## Addendum #1

### Big Spring Creek Restoration Near Lewistown

#### FWP Contract #15-31

5/6/16 10:27 AM  
Sheet 7 of 21

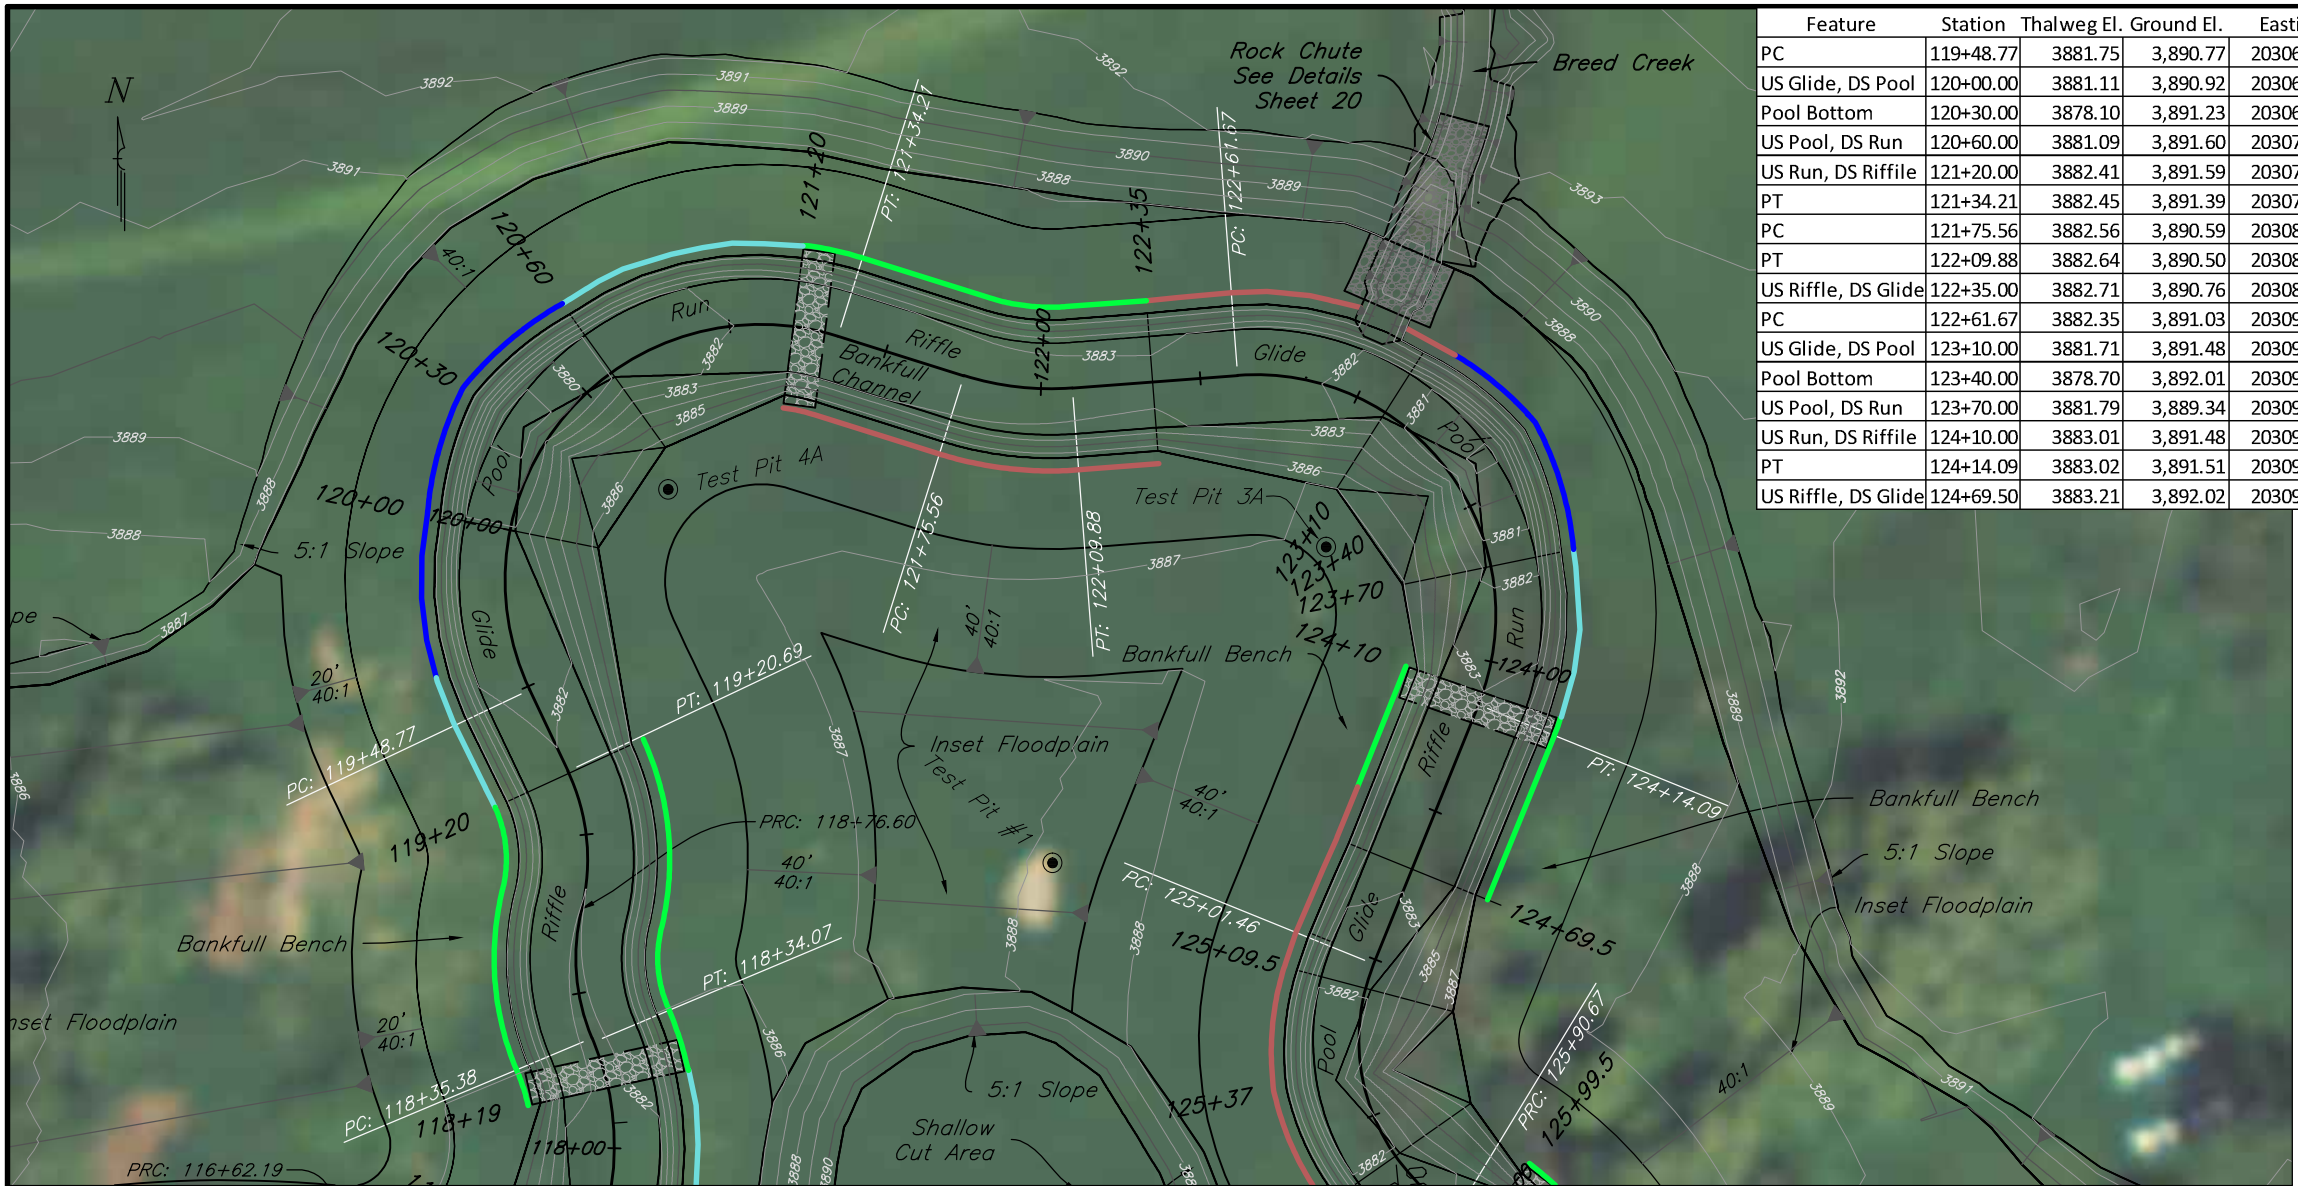
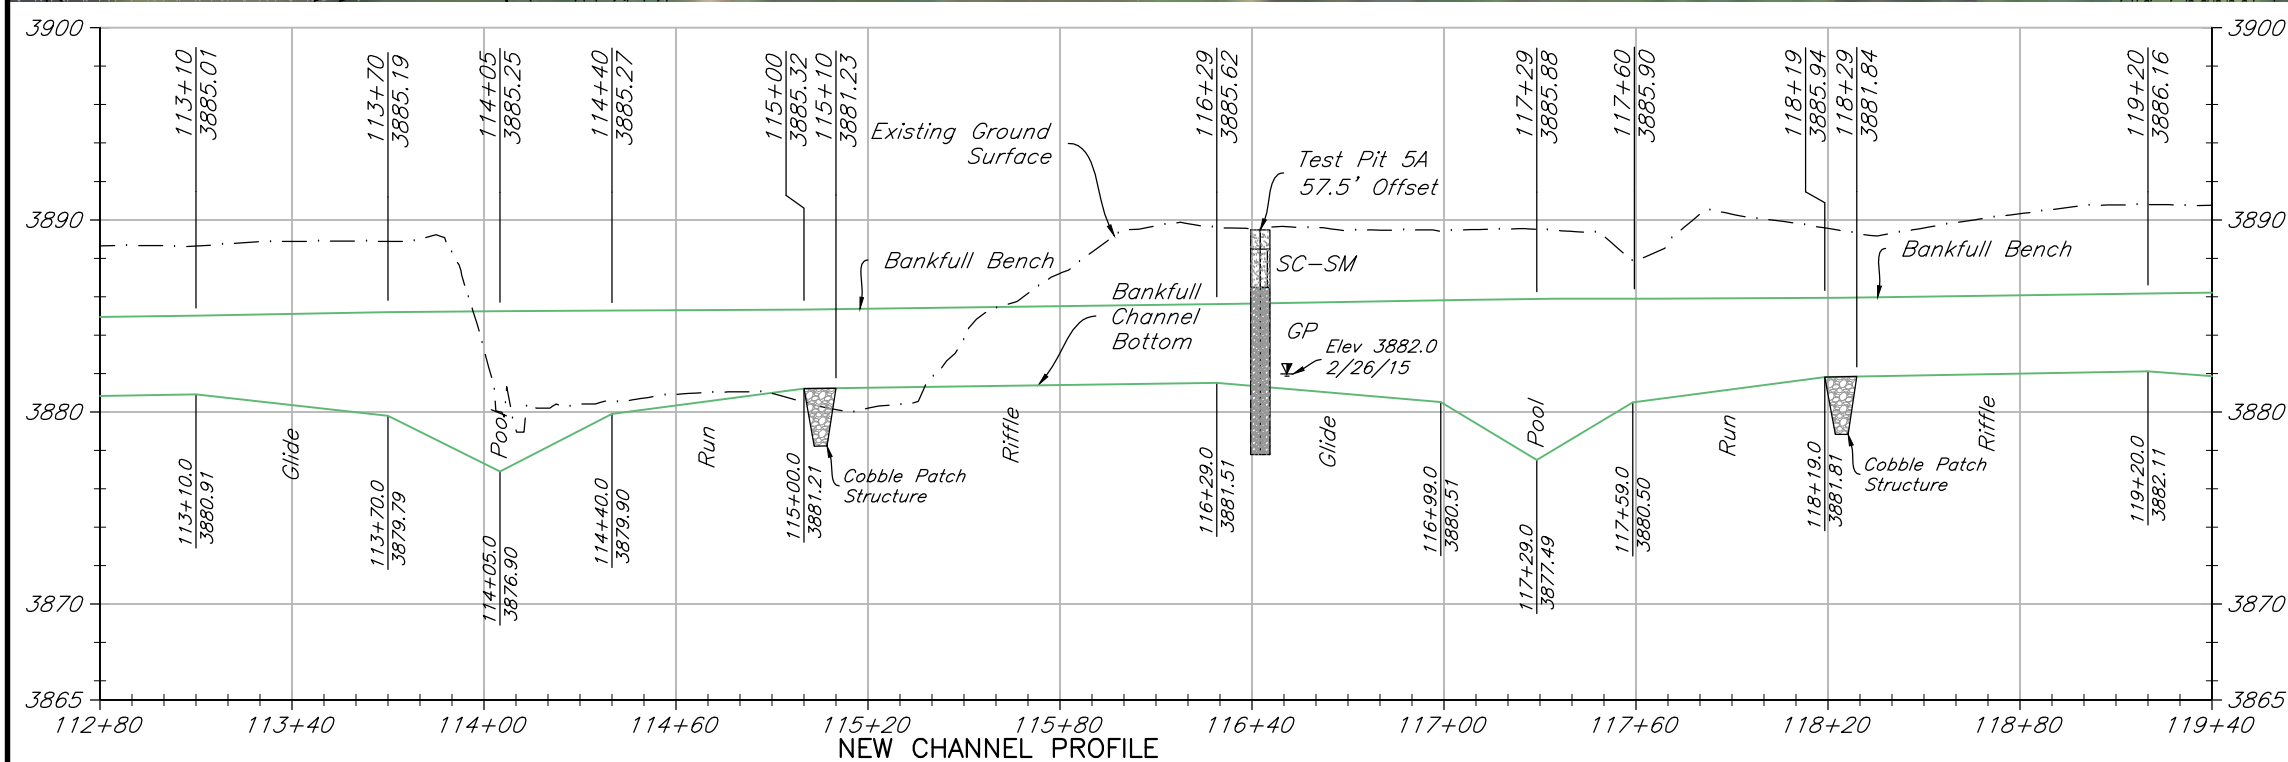
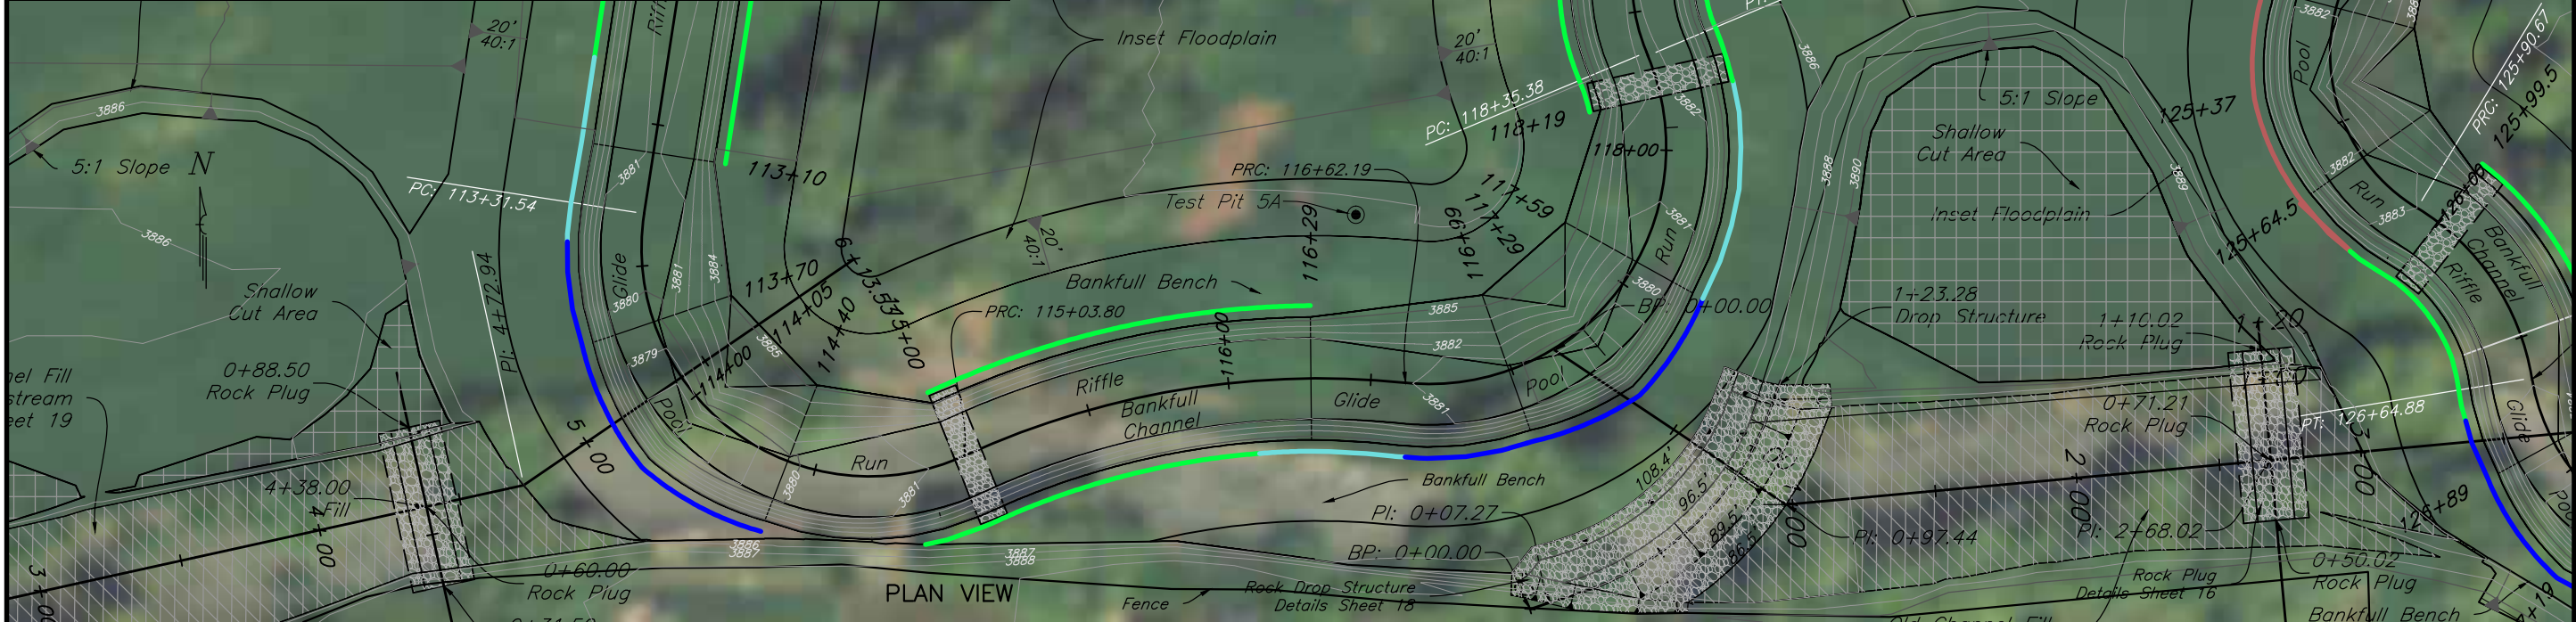
- **All Sheets**
  - Contour labels noting elevation were added.
  - Date stamp in the lower right hand corner was reset to May 6, 2016.
- **Sheets 7 and 8:** Hatching was added to represent “Shallow Cut Areas”
- **Sheet 11:** The channel-side limit of the “inset floodplain” was adjusted to match the floodplain-side limit of the bankfull bench on the Typical Floodplain Section
- **Sheet 21:**
  - Minor (less than 25 ft) adjustments were made in Work Limit Boundary corners on Sheet 21.
  - Ingress/egress along Hwy 191 south of the bridge was shifted south to better reflect the actual gate location.
